Anthropomorphic Test Devices; ES-2re Side Impact Crash Test Dummy 50th Percentile Adult Male

ACTION: Final rule, response to petitions for reconsideration, technical amendment.

SUMMARY: This final rule responds to petitions for reconsideration of a December 6, 2006 final rule establishing in 49 CFR part 572 a new mid-size adult male side crash test dummy, called the "ES-2re" test dummy. The petitions were submitted by the Alliance of Automobile Manufacturers, First Technology Safety Systems, and Denton ATD. In response to the petitions, this document slightly revises the specifications for conducting the neck assembly qualification test, narrows the tolerances for the tuning spring rates for the dummy's thorax, revises performance corridors for the full body thorax test, corrects cross-references in the Part 572 regulatory text and makes minor changes to the drawing package and user's manual for the test dummy.

FIGURE 1: FULL BODY THORAX IMPACT TEST RESULTS FOR UPPER RIB DEFLECTION

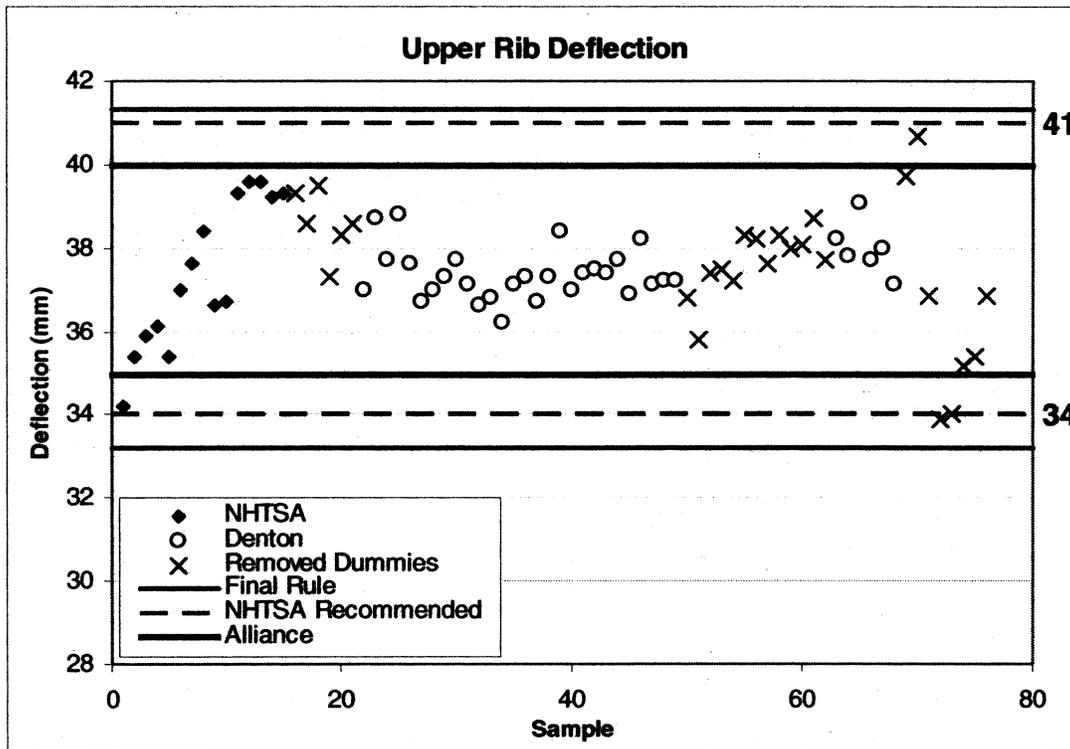
All of the data in the complete dataset (i.e., without any dummies removed) fit within the specified final rule corridor of 33.2–41.3 mm, as seen in Figure 1 below. The Alliance petitioned to narrow the corridor bounds to a range of 35–40 mm. The data set with the

indicated dummy responses removed (“revised data set”) has a mean deflection of 37.4 mm, a standard deviation of 1.11 mm and a CV of 2.96 percent. In that this CV is less than 3 percent, we could adopt corridor bounds that are expanded ±3 standard deviations from the mean,¹⁴ or a range

of 34.1–40.8 mm. When rounded to the next whole numbers away from the mean, this corridor becomes 34–41 mm, which is only slightly narrowed compared to the final rule. This corridor contains nearly all the NHTSA and DTESC data points, and is well-centered about the mean.

FIGURE 2: MIDDLE RIB DEFLECTION RESULTS FROM FULL-BODY THORAX IMPACT TESTS

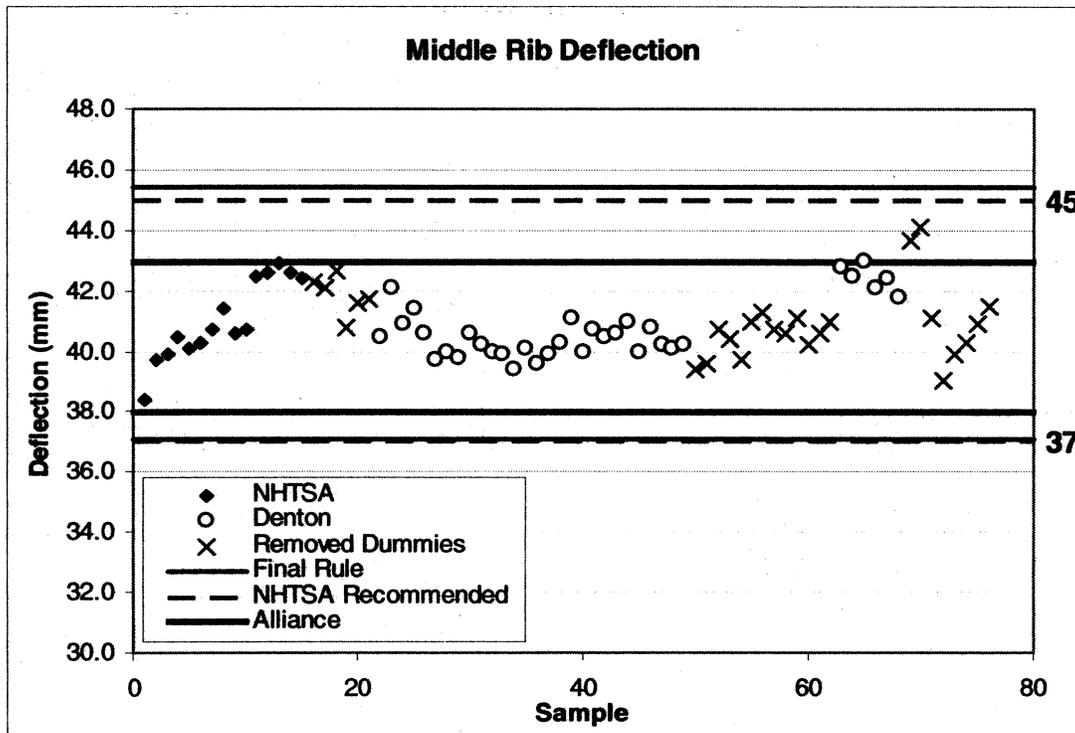
All data in the complete DTESC data set also fit within the corridors specified in the final rule for middle rib deflection, 37.1–45.4 mm (see Figure 2 below). However, the Alliance petitioned for narrowed corridor bounds

of 38–43 mm. Statistical analysis of the revised data set resulted in a mean response of 40.8 mm, a standard deviation of 1.09 mm and a CV of 2.67 percent. This CV allows for corridor bounds placed at ±3 standard deviations from the mean, or a range of 37.6–44.1 mm (37–45 mm when rounded away

FIGURE 3: LOWER RIB DEFLECTION RESULTS FROM FULL BODY THORAX IMPACTS

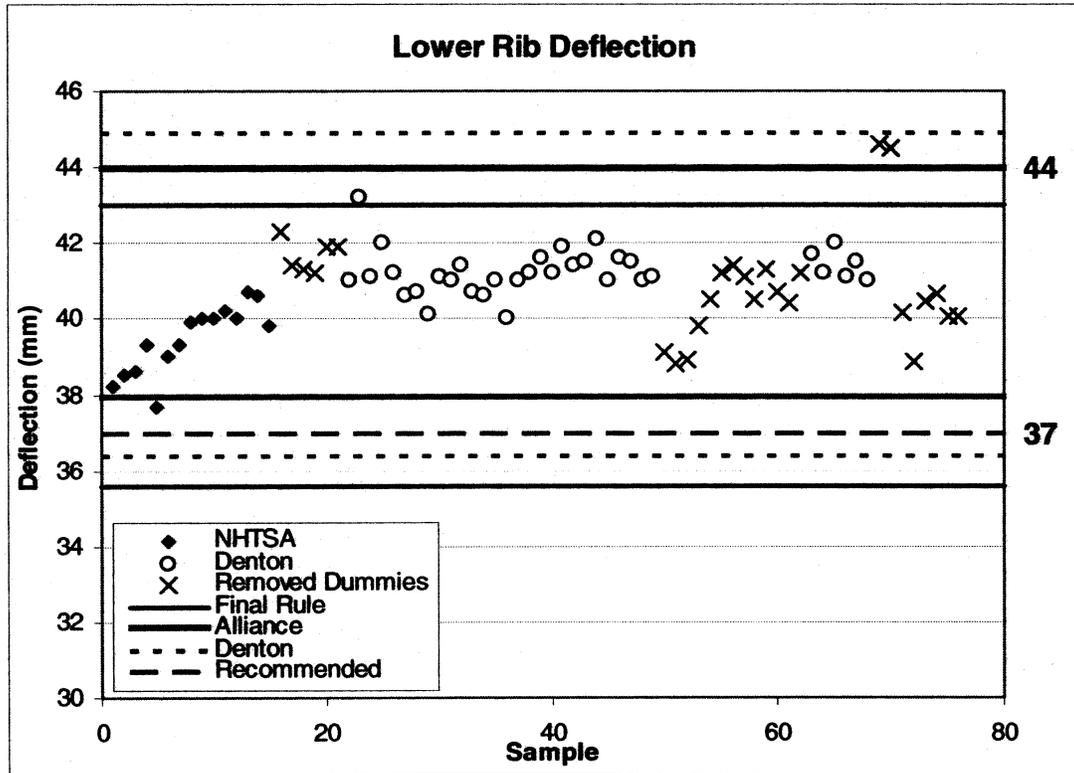
Denton and GM dummies in the DTEESC-compiled data set submitted in Denton's petition for reconsideration show deflections that are generally higher than those measured by NHTSA. The final rule specified a range of 35.6–43.0 mm, while the Alliance and Denton recommended corridors ranging from 38–44 mm and 36.4–44.9 mm,

respectively. Based on statistical analysis of the revised DTEESC data set, an adjustment of the corridor bounds to reflect these higher responses from a larger population of dummies is appropriate. The revised data set has a mean response of 40.7 mm, a standard deviation of 1.08 mm, and a CV of 2.66 percent. This CV allows for expansion of the bounds ± 3 standard deviations

from the mean, producing a range of 37.5–43.9 mm, or 37–44 mm when rounded away from the mean. This corridor is slightly smaller than and shifted upward from the final rule corridor, but wider than the corridor for which the Alliance petitioned. This corridor contains nearly all petitioner-submitted data as well as all NHTSA data (Figure 3).

FIGURE 4: TEST RESULTS FOR THE “PEAK IMPACTOR FORCE AFTER 6 MS” MEASUREMENT AS COLLECTED BY NHTSA, DENTON, GM AND FTSS

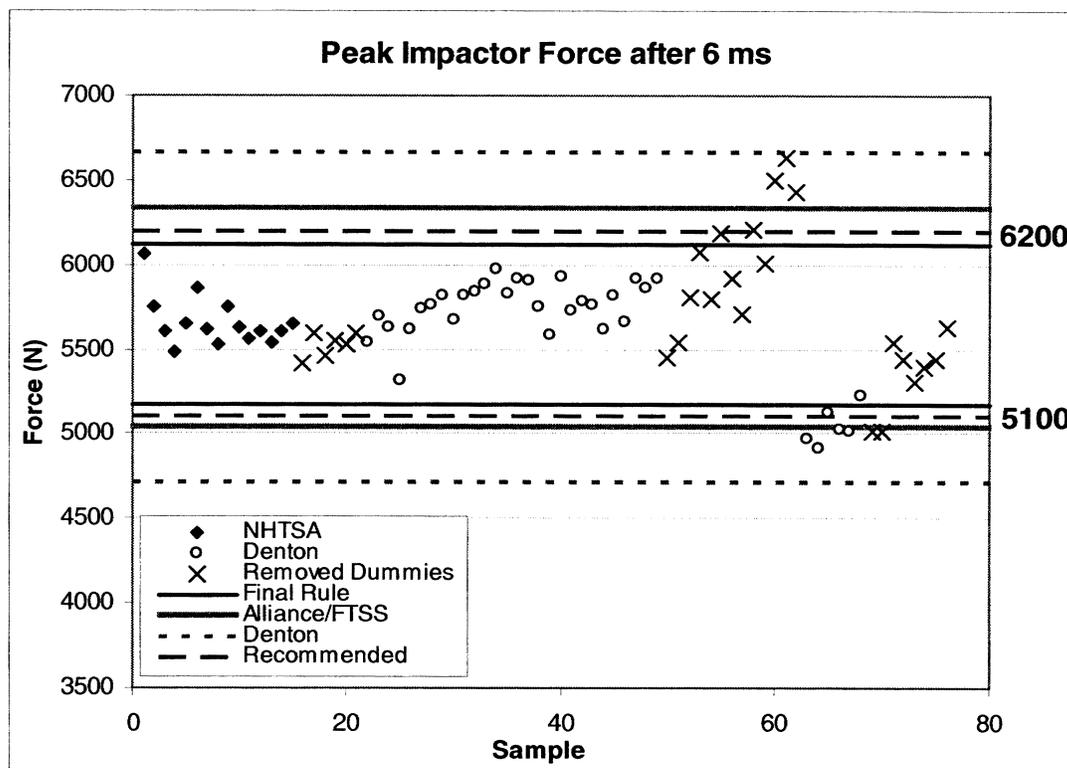
The additional peak impactor force data compiled by the SAE DTESC and submitted by Denton provide additional points with which to form statistically-based corridors. In its petition, the Alliance used this data set to propose a corridor of 5045–6344 N, while Denton recommended a range of 4720–6669 N,

as shown in Figure 4. FTSS recommended a performance corridor of 5039–6159 N for this measure. (The FTSS corridor is close to the Alliance recommendation, therefore to avoid clutter in Figure 4, it is shown to correspond to the Alliance corridor.) The mean response derived from the revised data set was 5643 N, with a SD

of 268 N and a CV of 4.76 percent. This CV allows for setting the corridor limits at ± 2 standard deviations from the mean, at 5107–6180 N. Rounded away from the mean, the lower and upper corridor bounds of the recommended corridor are 5100 N and 6200 N, respectively, a range very close to that which was petitioned by FTSS.

Figure U2-A
NECK/LUMBAR SPINE/HEADFORM ATTACHED TO PENDULUM

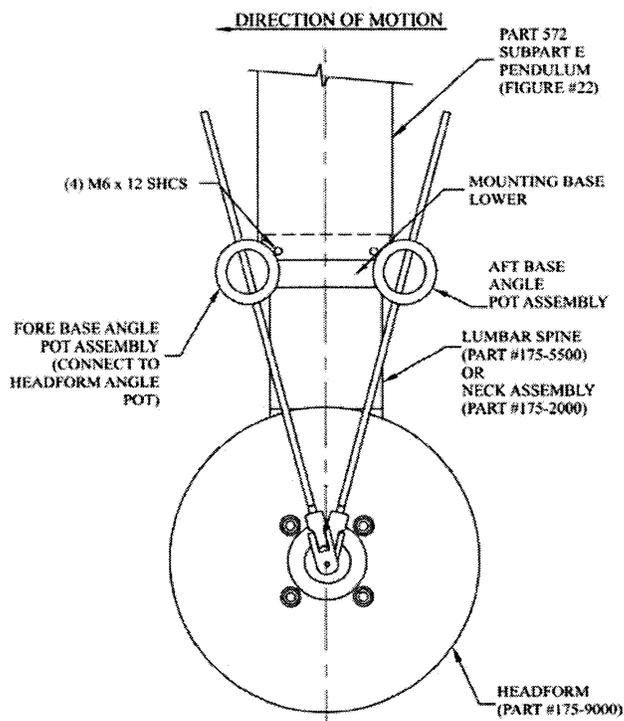
11. The agency has found an error in Figure U2-A, which specifies the pendulum for neck/lumbar spine qualification tests to be the "Part 572 Subpart E Pendulum (Figure #15)". The description and figure number do not refer to the same pendulum. This document makes a technical amendment by correcting the reference to read, "Part 572 Subpart E Pendulum (Figure #22)".

■ 8. Figure U2-A in "APPENDIX A TO SUBPART U OF PART 572—FIGURES" is revised to read as follows:
